H. B. ROBINSON STEAM ELECTRIC PLANT, UNIT NO. 2
DOCKET NO. 50-261/RENEWED LICENSE NO. DPR-23

Subject: **Response to NRC Request for Additional Information Regarding Supplemental Response to Generic Letter 2004-02 (EPID L-2017-LRC-0000)**

RESPONSE TO NRC REQUEST FOR ADDITIONAL INFORMATION ON THE FINAL SUPPLEMENTAL RESPONSE TO NRC GENERIC LETTER 2004-02, "POTENTIAL IMPACT OF DEBRIS BLOCKAGE ON EMERGENCY RECIRCULATION DURING DESIGN BASIS ACCIDENTS AT PRESSURIZED-WATER REACTORS"

Figure 5.1-3 - Nukon® and Temp-Mat™ Fibrous Insulation Debris Transport Logic Tree

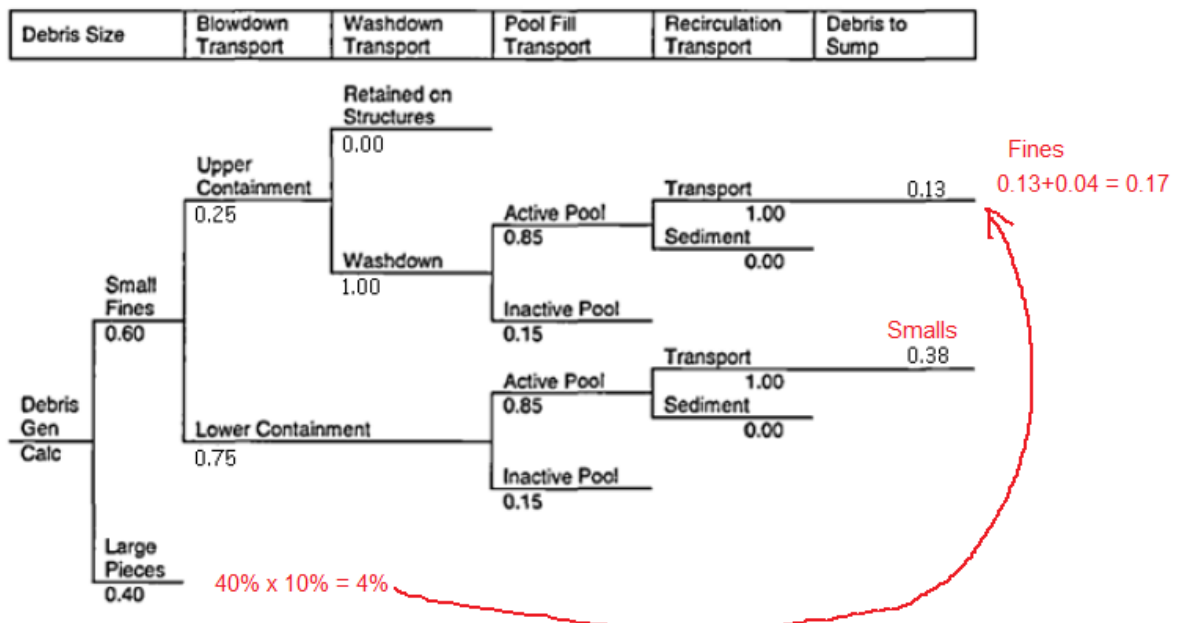
Provide the methodology for calculating the transport fractions provided in the debris table in Section 3.n.1.4 of the final supplemental response.

The logic tree for Nukon® and Temp-Mat™ fibrous insulation debris incorporates the fiber debris size distribution of 60% small debris and 40% large debris, which is from the NEI 04-07 Baseline Methodology and endorsed by the NRC. The 60% fraction for fines includes consideration for fibrous erosion. The overall transport fraction for the small fines is determined by summing the proportions for each of the paths from the zone-of-influence (ZOI) to the ECCS sump. The total Nukon® and TempMat™ fibrous insulation small fines transport fraction is 51%. An additional 10% of large pieces (40% of total) are assumed to deposit on the screens as fines (Ref. 5).

The overall transport fraction for Nukon and Temp-Mat small fines is determined by summing the proportions of each of the paths from the ZOI to the ECCS sump. The total Nukon and Temp-Mat fibrous insulation small fines transport fraction is 51%. An additional 10% of large pieces (40% total) are assumed to deposit on the screens as fines, or 4%, for a total of 55% (Ref. 5, Figure 5.1-3). Per Appendix II, Section II.3.1.1 of the NEI 04-07 Safety Evaluation Report, 75% of fibrous debris designated as “small fines” are assumed to be fibrous “small pieces” or “smalls”, and 25% of the “small fines” are assumed to be “individual fibers” or “fines”.

Based on this, the specific transport fractions of Nukon and Temp-Mat small fines for the penetration test are calculated as follows:

Percent "smalls" = (0.75 x 0.51) x 100 = 38%

Percent "fines" = (0.25 x 0.51 + 0.04) x 100 = 17%
